APPENDIX B

Summary of DRA Analysis of Late-Filed ALJ Exhibits

A. Estimation of hydrotest costs used to calculate disallowances for pipe replacement projects

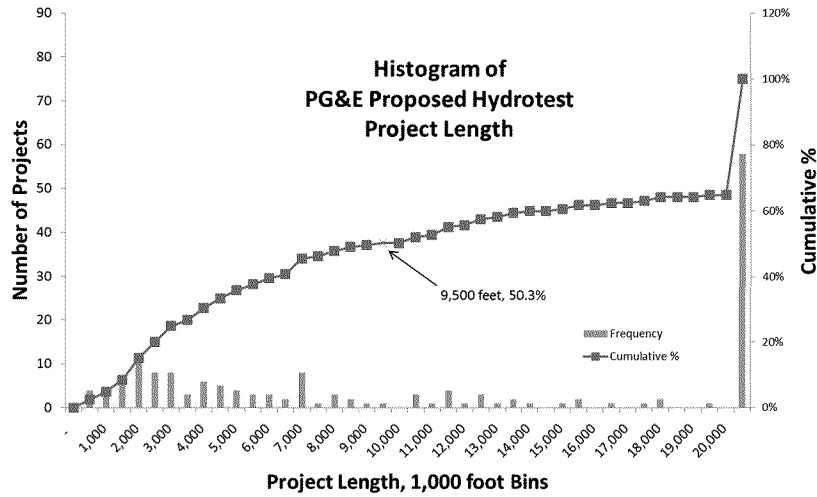
In addition, the record shows that hydrotest costs per foot decrease with increased length of a project, as fixed costs are spread over a larger length of pipe. The following chart shows hydrotest costs per foot for PG&E’s 165 proposed hydrotests projects, as a function of the length of each project:

This chart shows that short test projects, including all those shorter than 10,000 feet, have a cost per foot higher than \$95.8.

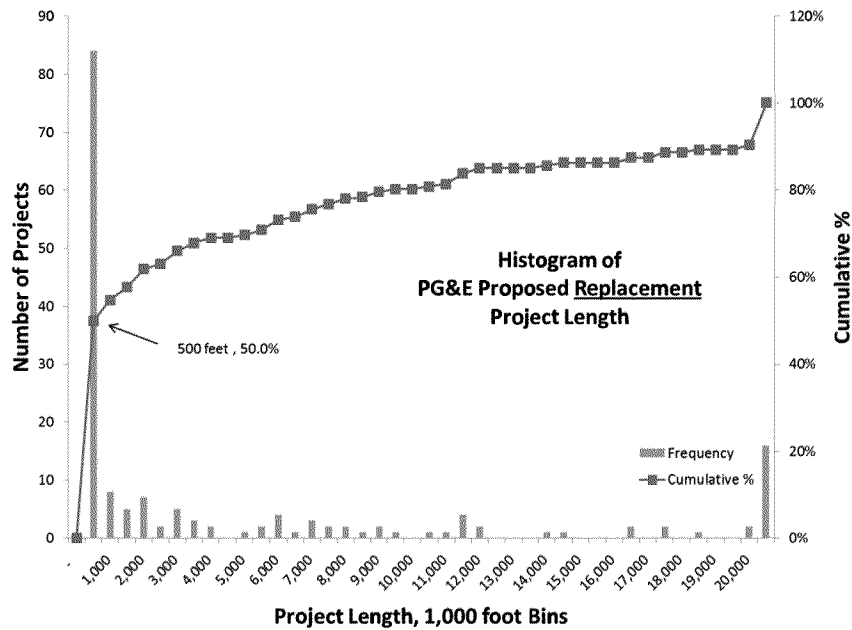
histogram of the 165 hydrotests shows the number of tests (y axis) within each project length bin (x axis):¹¹

This chart shows that approximately 2/3 of the *hydrotest* projects are longer than a mile, and 58 projects are longer than 20,000 ft. These long projects, which have a low cost per foot as shown above, drive the average cost per foot used in the PD.

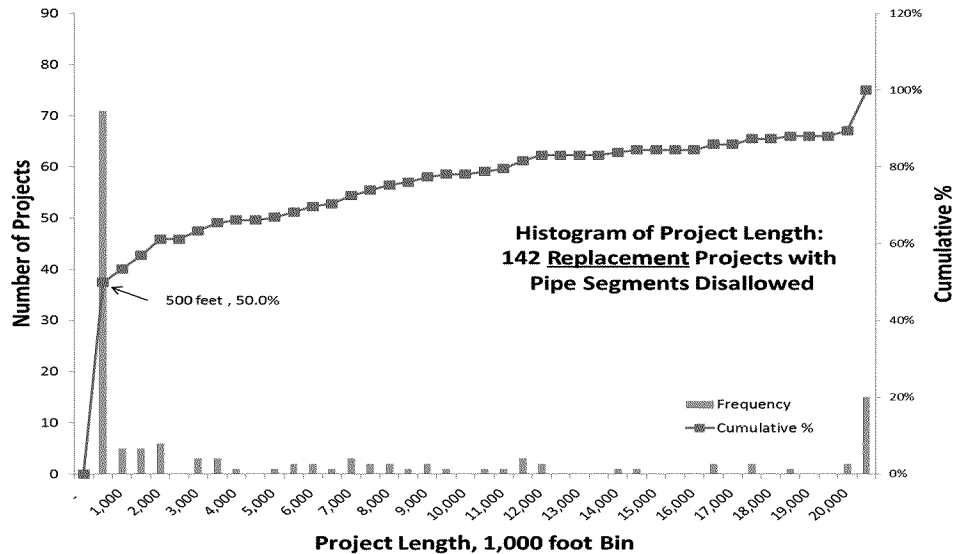
In comparison, the median length of PG&E’s proposed *replacement* projects is 509 feet, over 17 times less than the median length of *hydrotest* projects:¹²

This chart shows that the majority of proposed *replacement* tests (84 of 168) are less than 1,000 feet long.

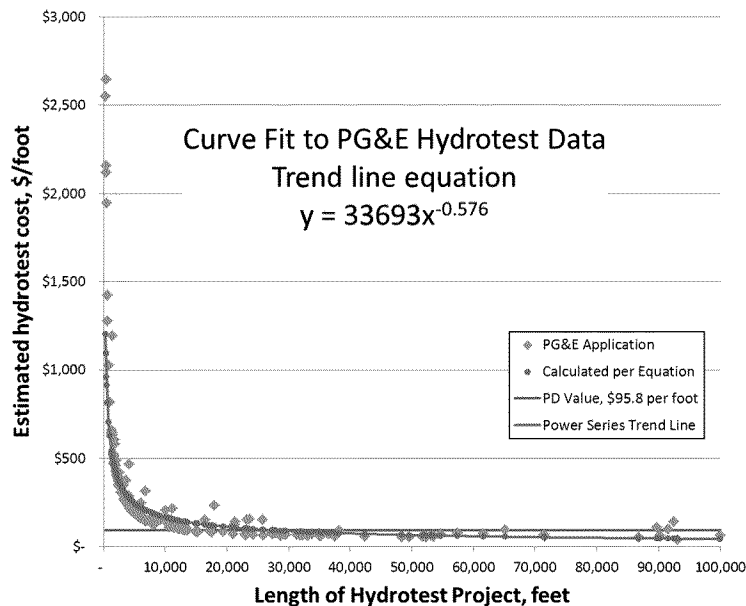
Not all replacement projects have segments that are disallowed, regardless of whether PG&E or DRA’s cost allocation criteria are used. DRA therefore performed a similar analysis on the 142 replacement projects with disallowances using the criteria of Scenario 3 as described in Section II.A.2(a) of DRA’s Comments on the PD.¹³ The median value of these projects, 512 feet, and the frequency distribution are similar to the full set of replacement projects:¹⁴

This data shows that PG&E pipe *replacement* projects are much shorter than *hydrotest* projects, and that the single estimated hydrotest cost of \$95.8 per foot is inappropriately low for use for replacement projects, the majority of which have short pipe lengths.
